ZONING BOARD OF APPEALS

INTER-DEPARTMENTAL REVIEW COMMITTEE REPORT

1014 S. FINLEY ROAD

ZBA 25-01

Figure 1: Site Plan provided by petitioner

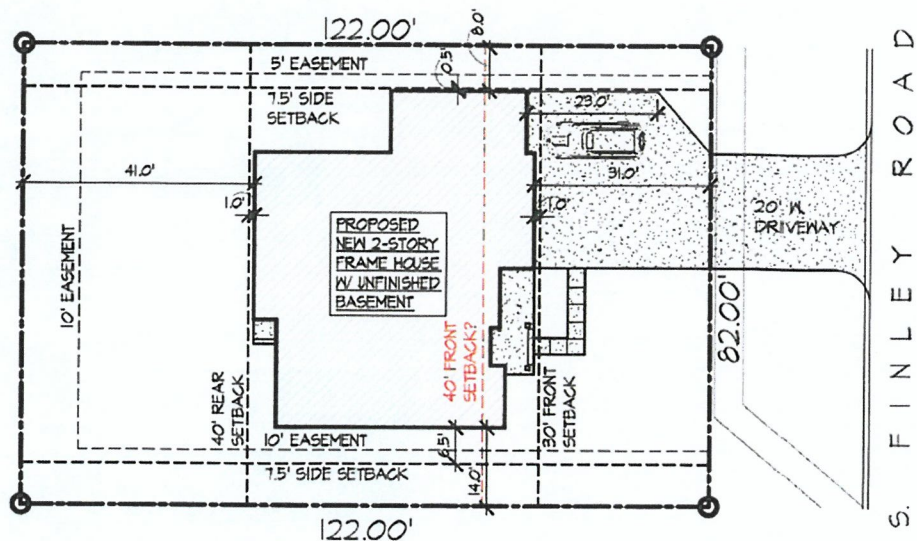
The proposed site plan does not require variances from the interior side or rear yards. The attached exhibit demonstrates the hardship of meeting the standard. In order to meet the required 40-foot setback the house would need to encroach into the rear yard setback of 40 feet. The petitioner is requesting a variance to permit a house to encroach 9 feet into the front yard setback. The result would be a front yard setback of 31 feet.

The attached exhibit demonstrates the hardship of meeting the standard. In order to meet the required 40-foot setback the house would lose buildable space area in depth as the lot is shallow compared to other lots zoned R1 in the Village. Out of 146 properties that are zoned R1, the average lot depth is 172 feet. Three of the lots zoned R1 have a depth of 400 feet or more and ten of the lots have a depth of 100 feet or less. There are eight lots that are zoned R1 within the Flowerfield Acres Subdivision where the subject property is located. The other six lots, not counting 501 W Edgewood and 1014 S. Finley Road (subject property), are 200 feet in depth or more. Staff notes a house built prior to 2011 could have a front addition added up to 30 feet without the mean of the abutting properties considered. The petitioner is requesting a variance to permit a house to encroach 9 feet into the front yard setback. The result would be a front yard setback of 31 feet.

Staff considers the conflict with the 2008 text amendment to be a unique circumstance of the subject property that impacts the ability of the petitioner to reasonably locate the building footprint of a house. Staff has no objection to the requested front yard setback variance.

A variation from Section 155.406(F)(1)(a) to allow a new single family residential structure to be constructed thirty-one feet (31') from the front property line where a front yard setback of forty feet (40') is required.

The Department of Community Development has determined that the information presented **has affirmed** the Standards for Variations for the requested variations. Based on the above considerations, the Inter-Departmental Review Committee recommends that the Zoning Board of Appeals make the following motion recommending **approval** of the aforementioned variations:
